T6K-V3S

Changes in T6K-V3S

Glider: Addition of the 2AIL-B to the wing type

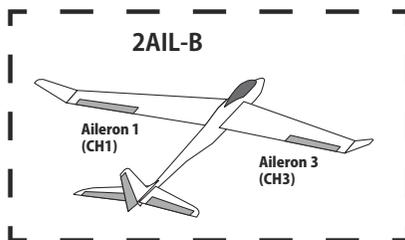
Conventional 2AIL → Aileron: CH1 and CH6
2AIL-B → Aileron: CH1 and CH3

2AIL-B is for non-powered gliders only. Engine and motor functions cannot be used.

Switch D changed to 3 positions.

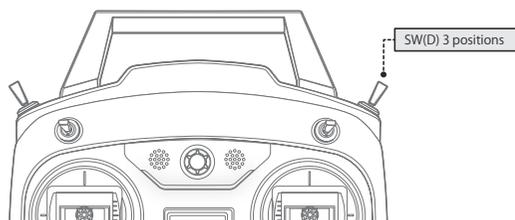
Switch D of T6K used to have 2 positions, but V3S has 3 positions.
